POWERPAY OFFICE
PORTLAND, ME

SKS-20

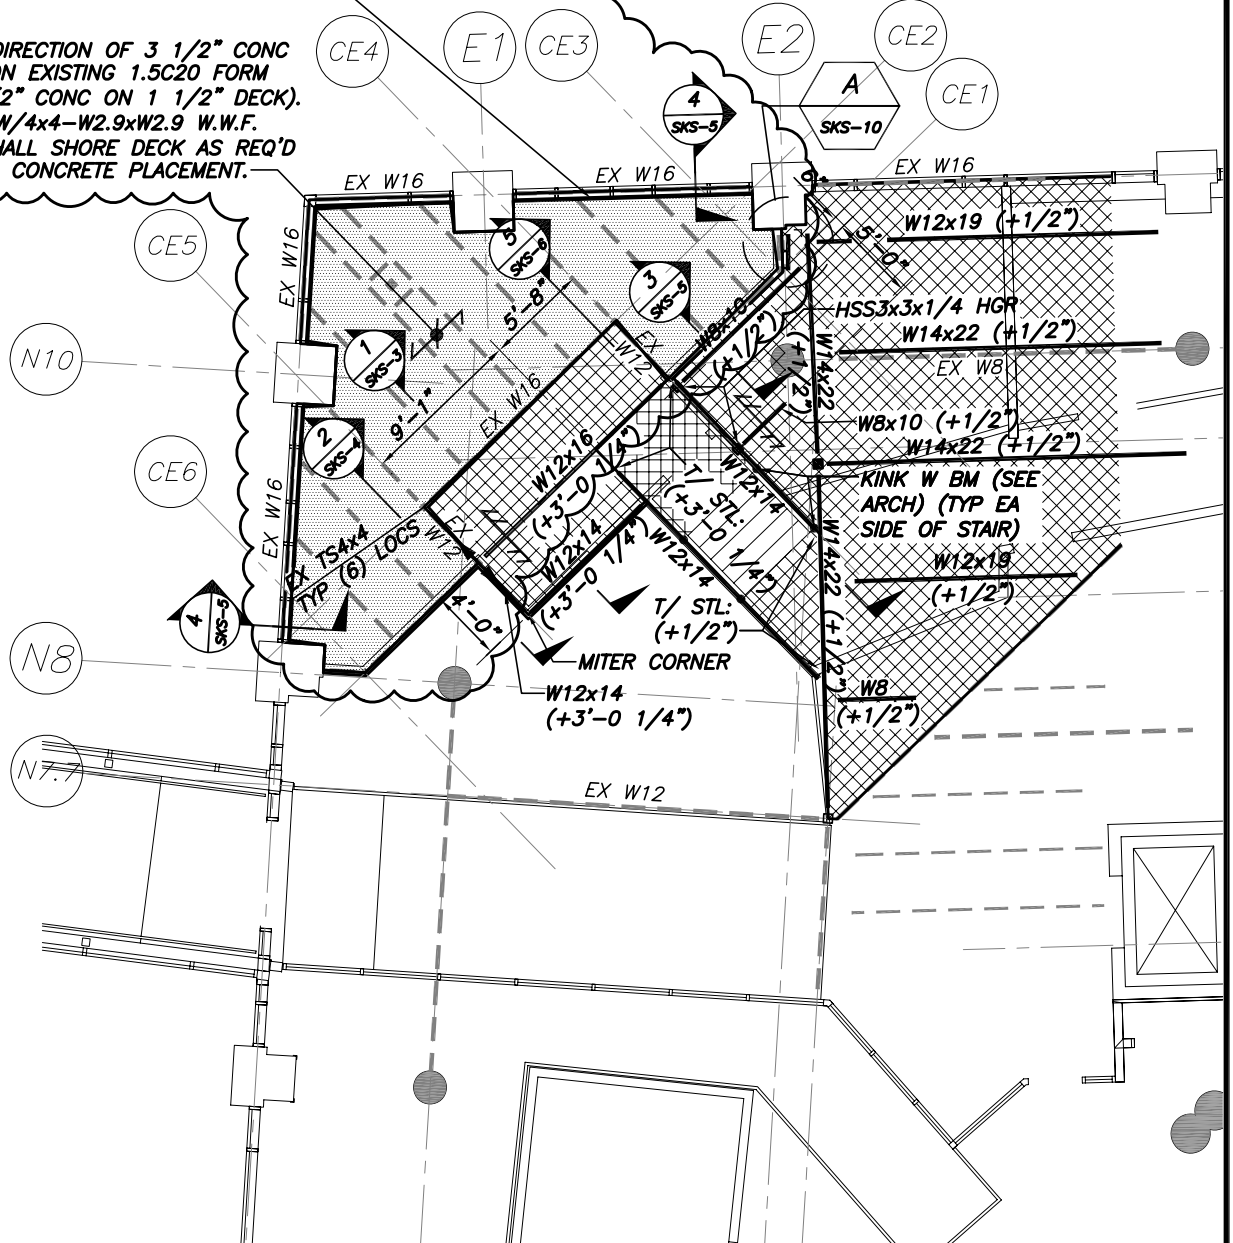
PROVIDE L3 1/2x3 1/2x5/16
SLAB SUPPORT @BLDG
PERIMETER WHERE REQ'D

SPAN DIRECTION OF 3 1/2" CONC
SLAB ON EXISTING 1.5C20 FORM
DECK (2" CONC ON 1 1/2" DECK).
REINF W/4x4-W2.9xW2.9 W.W.F.
G.C. SHALL SHORE DECK AS REQ'D
DURING CONCRETE PLACEMENT.

NOTE: EXISTING FRAMING SHOWN ON
PLAN IS FROM STRUCT DRAWINGS FOR
ORIGINAL BUILDING. G/C SHALL FIELD
VERIFY EXISTING FRAMING & NOTIFY
ARCH & STRUCT ENGINEER IF ANY
DISCREPANCIES PRIOR TO CONSTRUCTION
